Re: Addendum No. 1 to the South Orange County Reliability Enhancement Project Minor Project Refinement No. 1.

Addendum No.1 to MPR-1 Request for Approval

**MPR-1 FIGURE 1 ADDENDUM
SAN JUAN CAPISTRANO SUBSTATION**

South Orange County Reliability Enhancement Project CPUC Minor Project Refinement Form

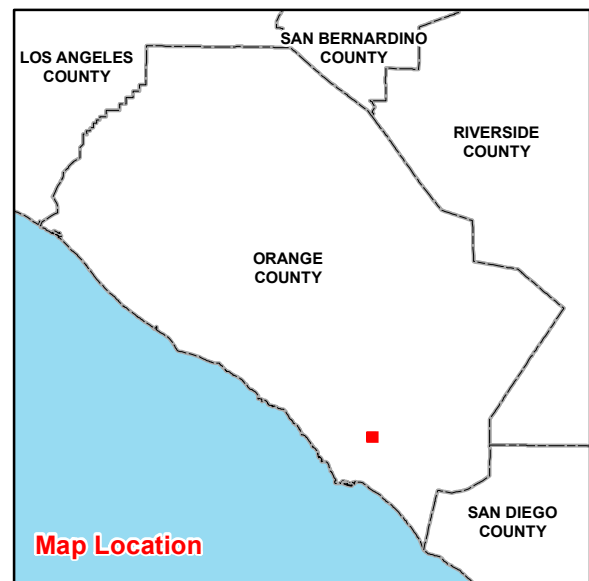
As mentioned above, MPR-1 authorizes SDG&E to use a new 18,300 square-foot temporary work area along the southern border of the San Juan Capistrano Substation for vegetation removal, backcutting and construction access associated with the installation of the screen wall. Within this previously approved temporary work area, SDG&E is now proposing to add a temporary driveway and security gate to provide access to the upper yard of the Substation during construction. Access to the upper yard of the Substation via the new driveway and gate would be for the use of SDG&E operations and maintenance personnel, so they can continue to maintain and operate the 138 kilovolt (kV) equipment in the upper yard without needing to drive through the active construction currently occurring in the lower yard. On average, SDG&E operations and maintenance personnel would utilize the new entrance to the upper yard once per day. In addition, SDG&E may utilize the temporary entrance intermittently during Phase 2 construction in the upper yard for the delivery of equipment and for an additional access point for construction personnel. Prior to using the temporary entrance during Phase 2 construction, SDG&E will provide a description of the type

The approximate 24-foot wide driveway would be established along with a 20-foot wide chain link security gate. The driveway would be created through the use of Class-II base and asphalt would be used to create a lip over the existing curb on Calle Bonita; however, the details regarding construction of the driveway would be coordinated with the City of San Juan Capistrano through the encroachment permit process. SDG&E operations and maintenance personnel would use the access through approximately Q3 2021, while construction activities in the 138/12 kV yard are occurring at the site. Phase 2 construction access would continue until the completion of the work in the upper yard anticipated in Q4 2022. At the completion of construction, and consistent with MPR-1, the temporary work area would be restored to pre-Project conditions or pursuant to agreements with the landowner.

ATTACHMENT B
MPR-1 Addendum Site Photographs

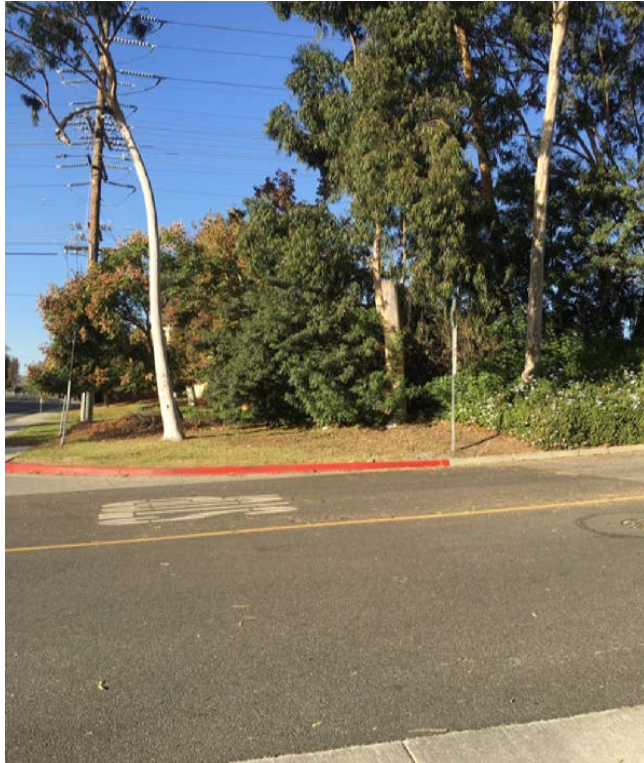
Approximate location of
new temporary driveway
and gate.
